Horncastle House, Plawhatch Lane, Sharpthorne
Our Ref: 29528-FLD-0101 Rev A
Drainage Technical Note
November 2025

Revision A of this Technical Note aims to address comments from West Sussex County Council (WSCC) as the Lead Local Flood Authority (LLFA), dated 29th July 2025, see **Appendix A**. The LLFA comments are provided below in *Italics* and a MEC response is provided in normal text, addressing each comment.

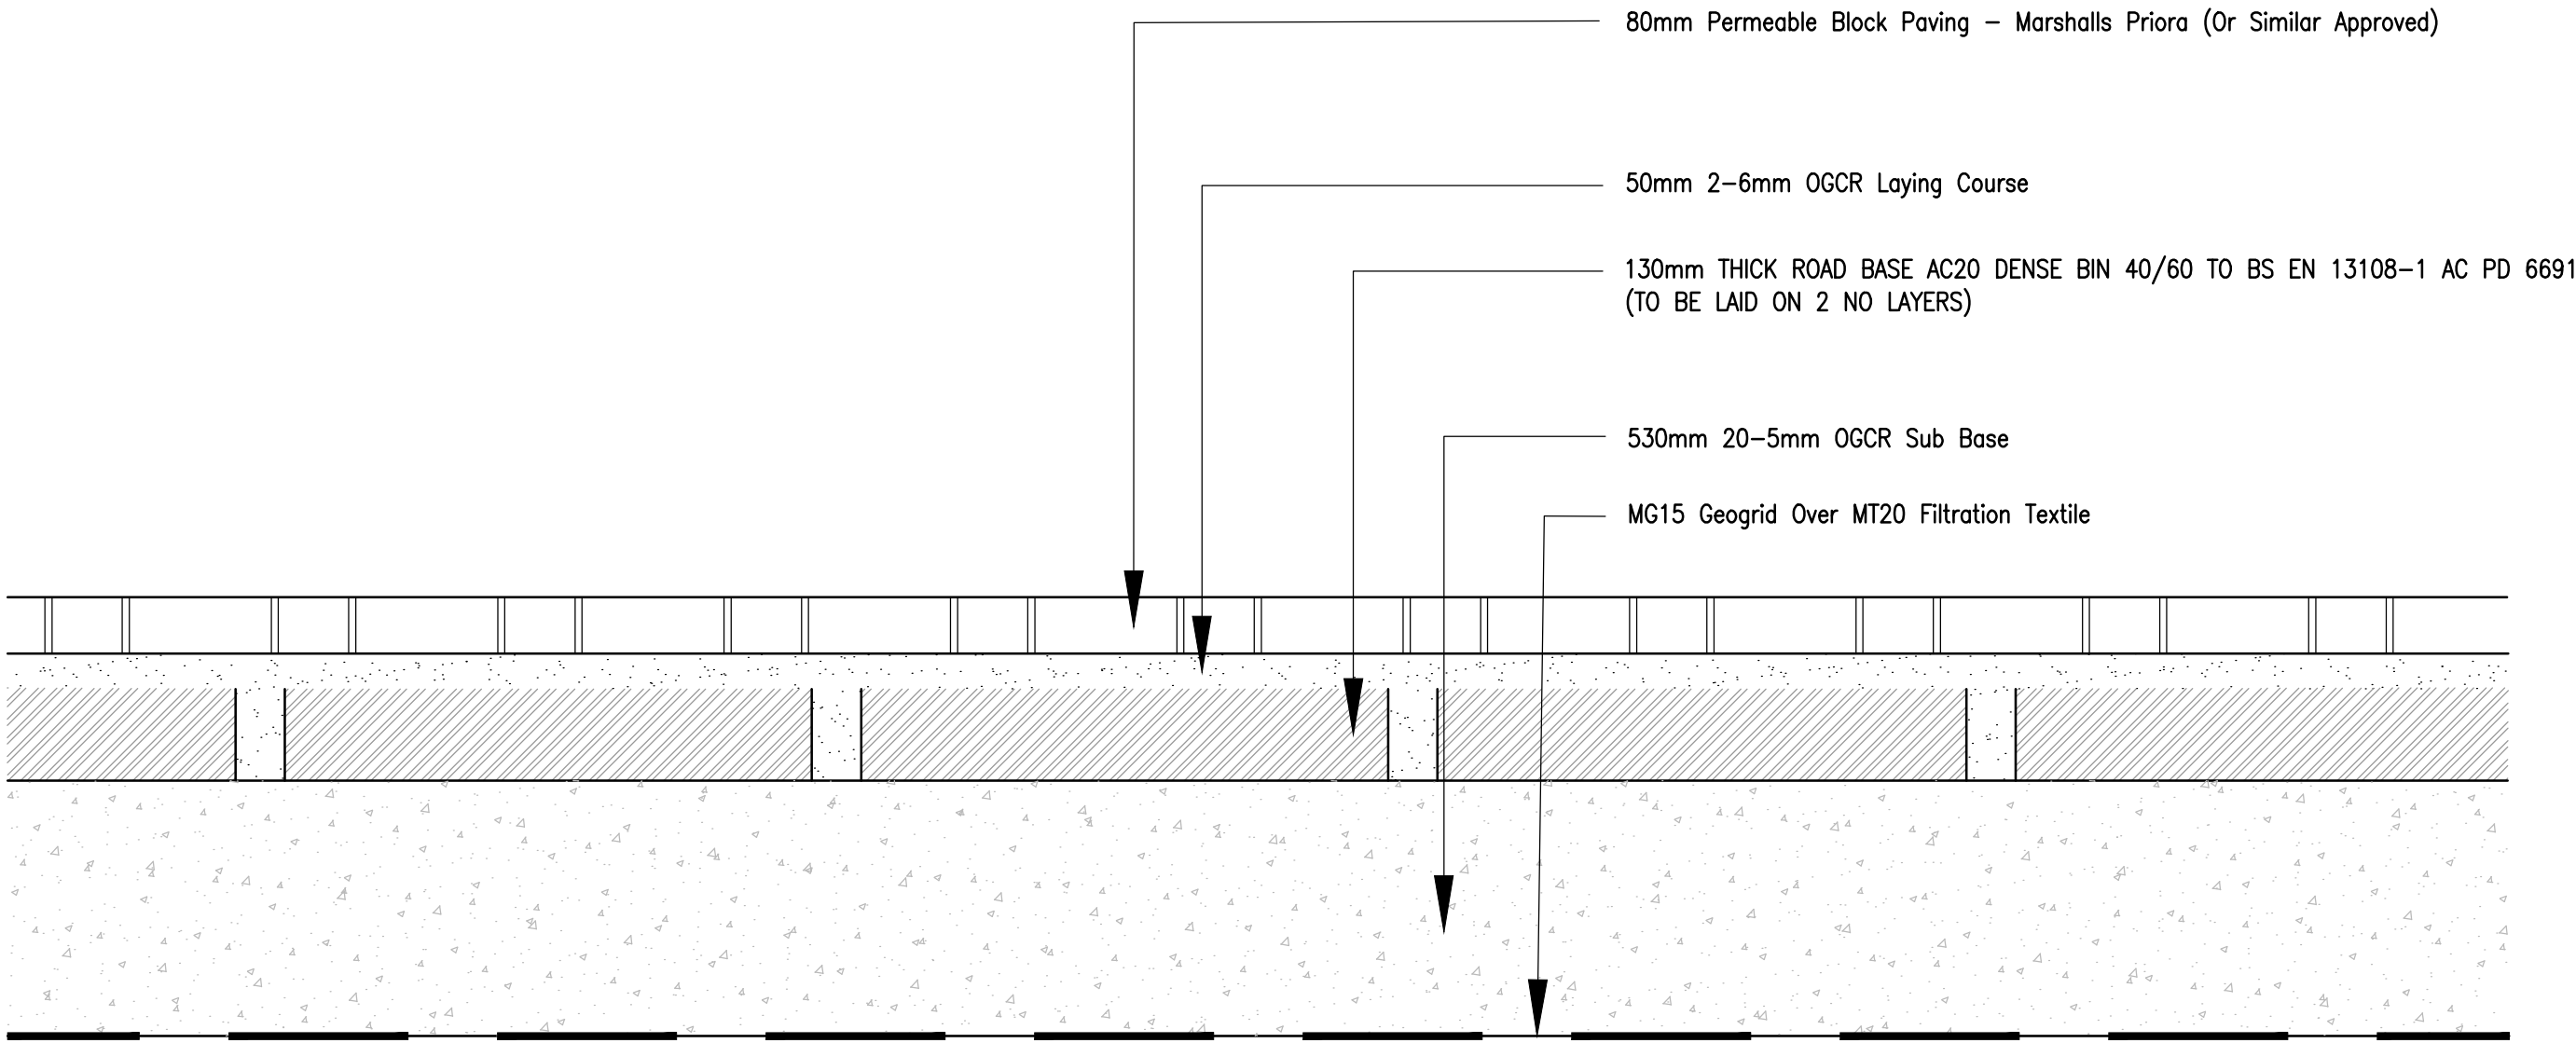
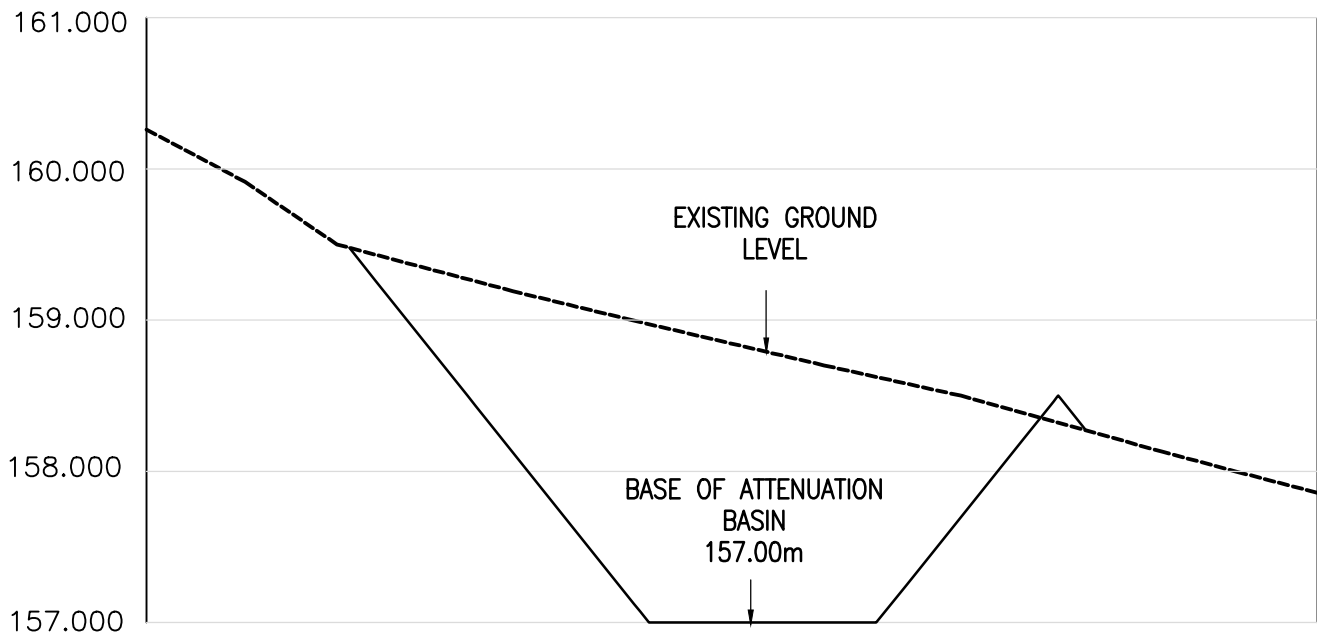
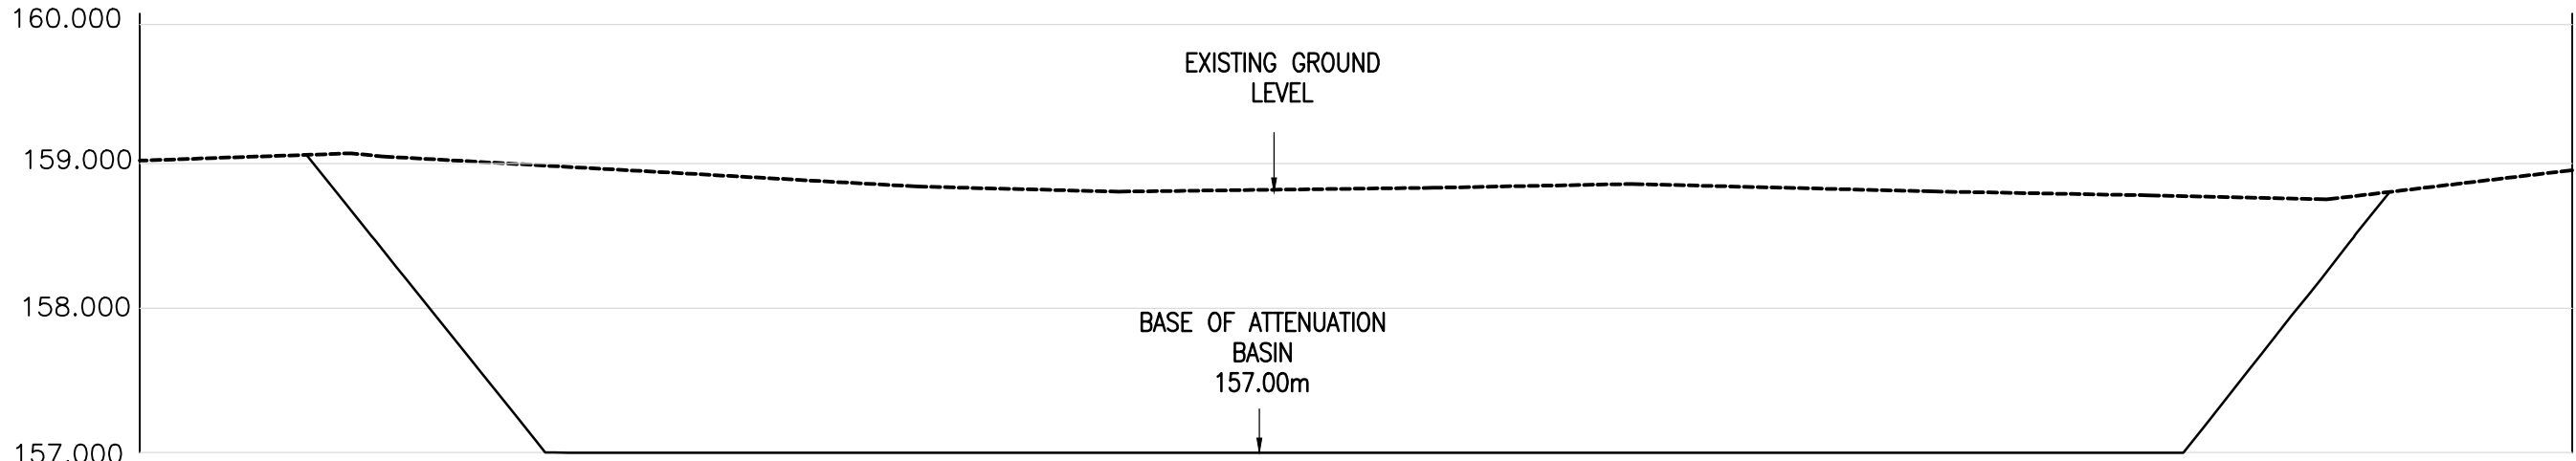
- *Cross-sections of permeable paving and the tank is required.*

Cross sections of the permeable paving and proposed attenuation basin are provided in **Appendix E**, see drawing 29528_01_230_03.
